BAeA Free Known Programme 1

Power Intermediate / Yak-52, Advanced and Unlimited 2018

Guidance for competitors

Advanced power category

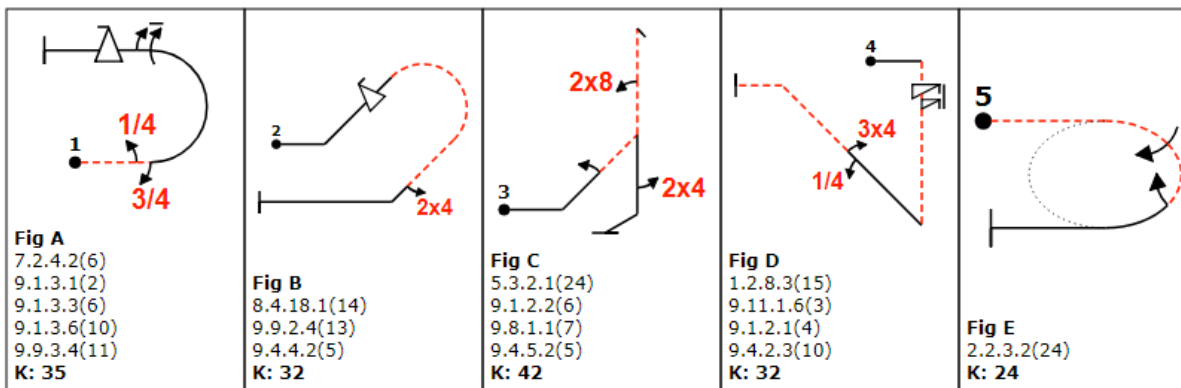
Note 3: In Advanced figure A the final 1½ rolls and the flick roll should be performed in the same direction. These two rolls have previously been shown in opposite directions, which was incorrect.

Unlimited power category

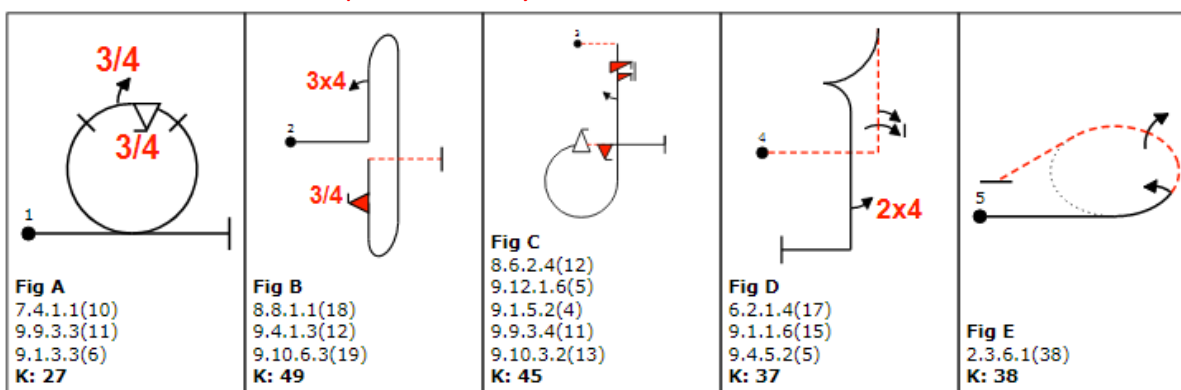
Note 1: Unlimited power Figure #3 has been revised from the original version

- The duplicated 2x4 roll (9.5.4.2) after the spin is now changed to a ½ roll (9.1.5.2)
- The flick-roll pair is now set to opposite directions per Aresti regulations

Note 2: Unlimited power Figure 'E' 2.3.6.1 is within the revised 2018 CIVA Section 6 Part 1 para 2.2.1.8 versatility range.
